City of Bristol
Conservation Commission/ Inland Wetlands and Watercourses Agency

REGULAR MEETING - MONDAY, JUNE 3, 2024
CITY HALL COUNCIL CHAMBERS
111 NORTH MAIN STREET
6:30 P.M.

AGENDA

Project No.: 702	Sheet
Date: 12/1/2022	WR-1
Drawn By: NP	
Checked By: SA	
Scale: AS SHOWN

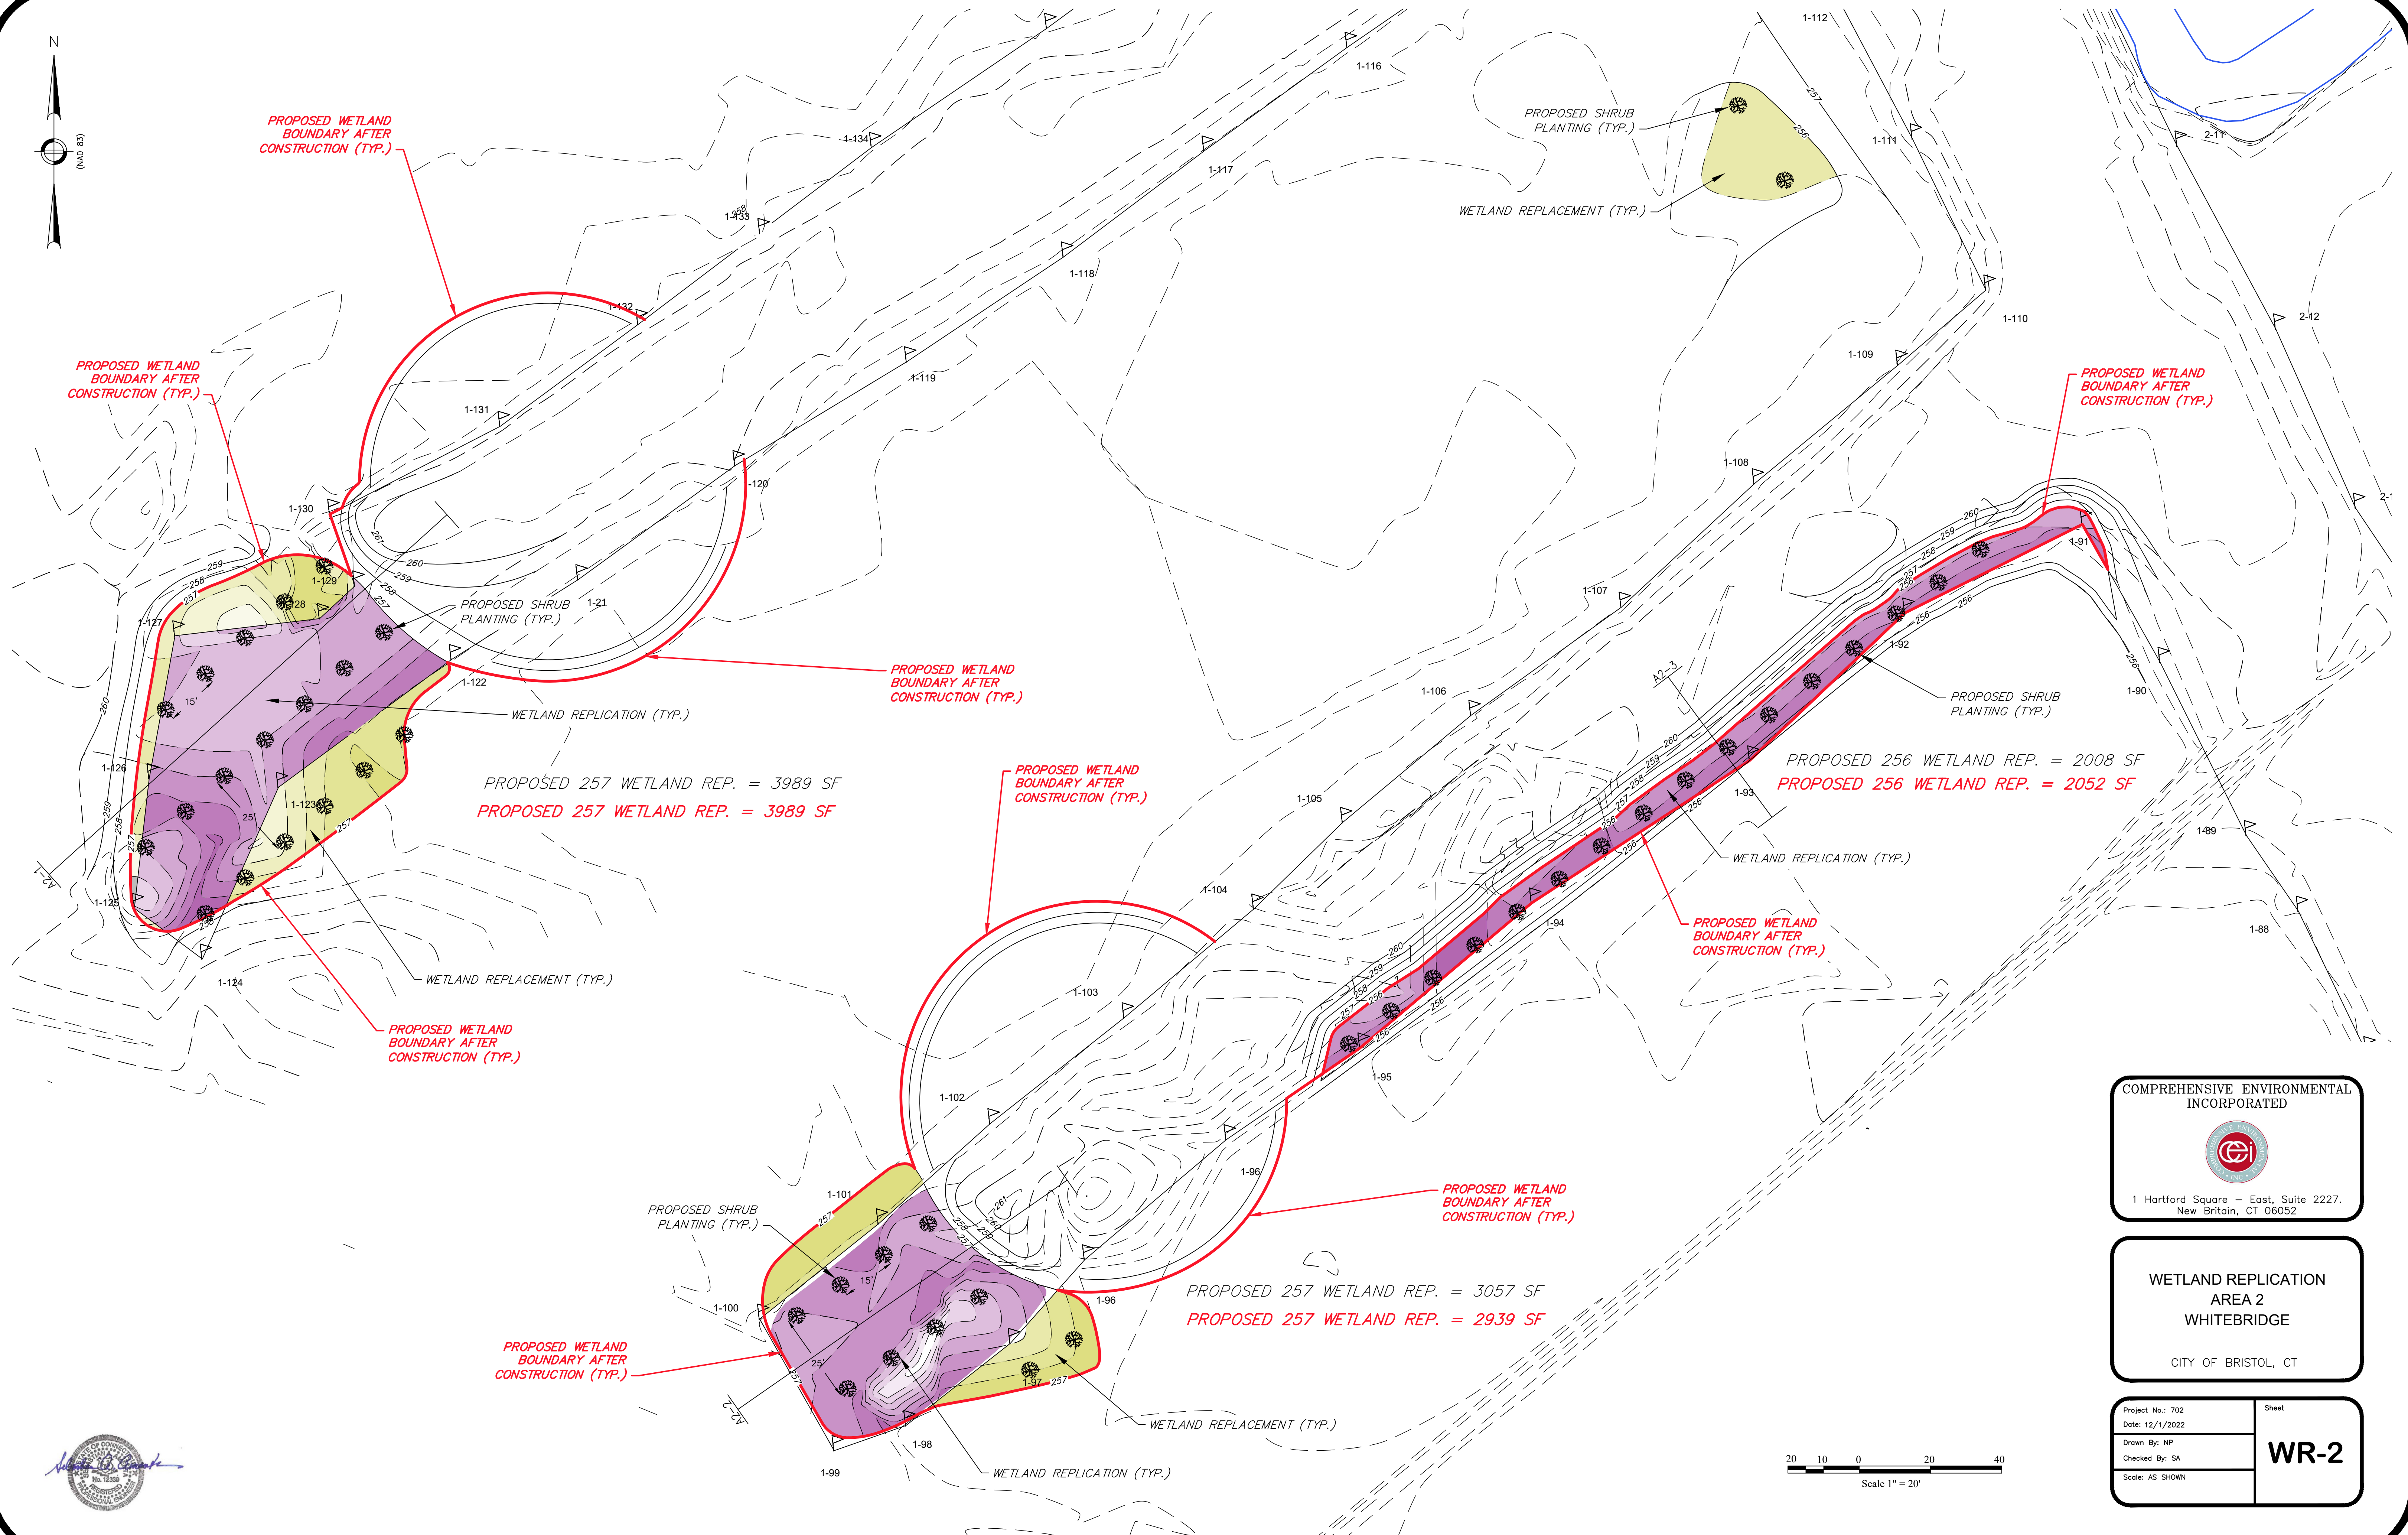
2. Regarding the revised wetland mitigation / floodplain compensation areas:
 - a. Sheet WR-1 shows a wetland replication area (represented by section A1-1) to excavate up to 8' in depth from an area of approximately 28,726 SF in size (to el 261). This area is located immediately adjacent to brook. The proposed transition slope areas to the north and west of this area add additional significant area of

2. Regarding the revised wetland mitigation / floodplain compensation areas:
 - a. Sheet WR-1 shows a wetland replication area (represented by section A1-1) to excavate up to 8' in depth from an area of approximately 28,726 SF in size (to el 261). This area is located immediately adjacent to brook. The proposed transition slope areas to the north and west of this area add additional significant area of

A4-1
SHEET WR-4
SCALE: 1' = 10'

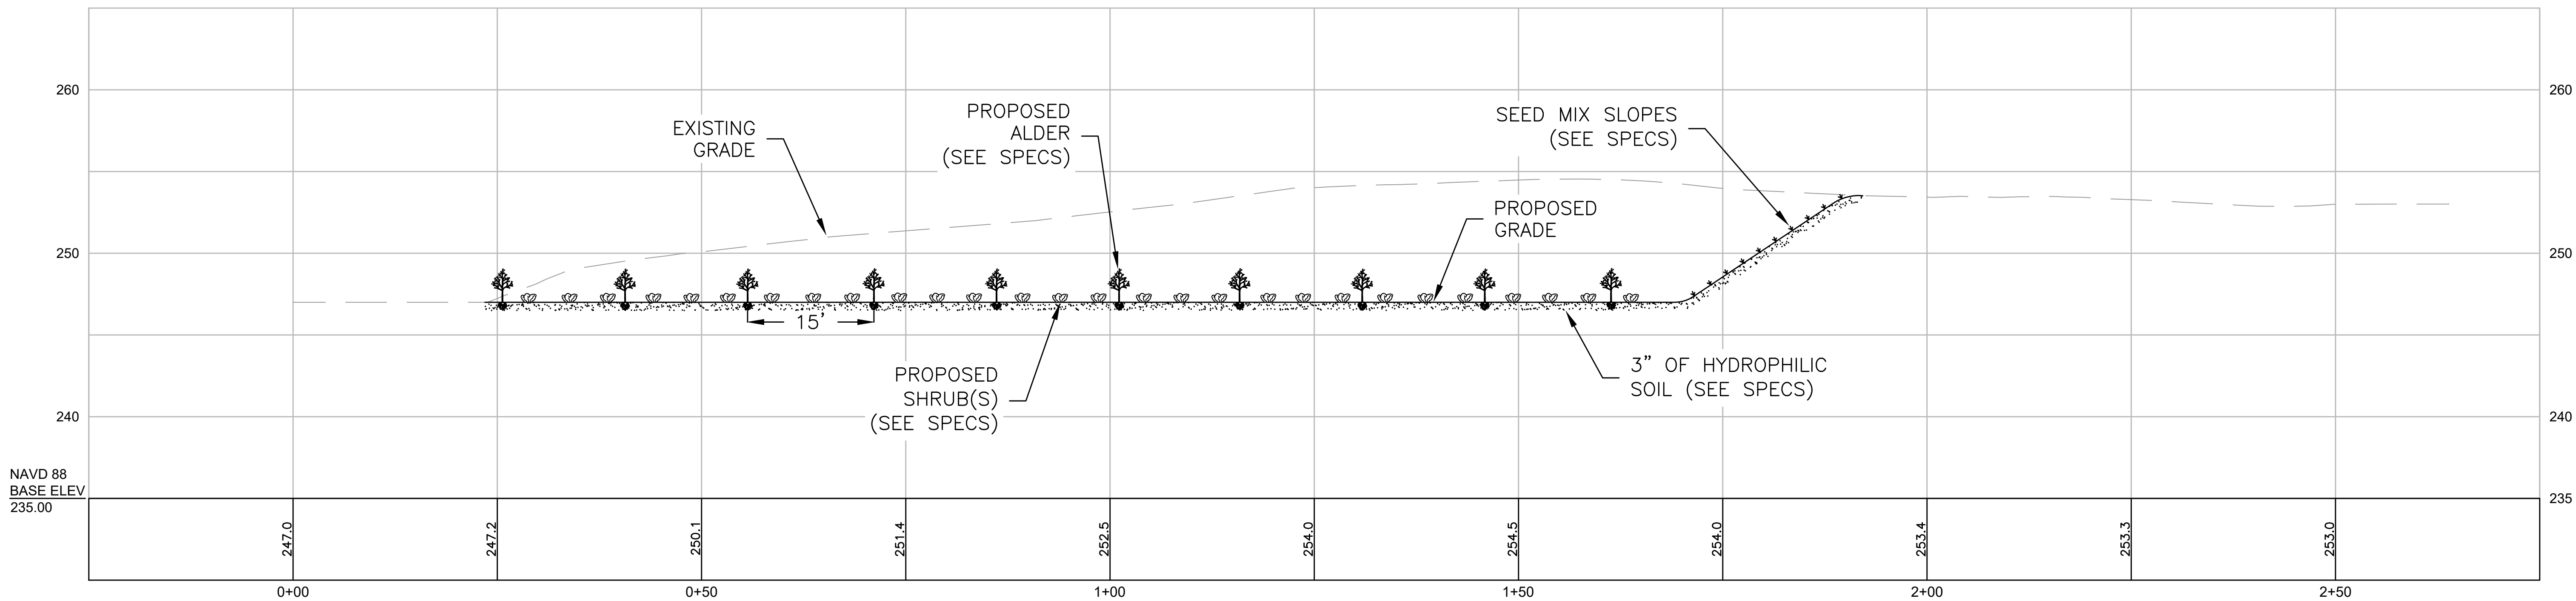
- d. On Sheet WR-4, the proposed replication area 7,000 SF graded to el 249 with an unidentified quantity of area graded to 252 and grassed (represented by Section A4-1). Please describe the existing and replacement land covers, label contours and tabulate the impacted areas, including slopes and access road, in the regulated wetland areas.

- d. On Sheet WR-4, the proposed replication area 7,000 SF graded to el 249 with an unidentified quantity of area graded to 252 and grassed (represented by Section A4-1). Please describe the existing and replacement land covers, label contours and tabulate the impacted areas, including slopes and access road, in the regulated wetland areas.
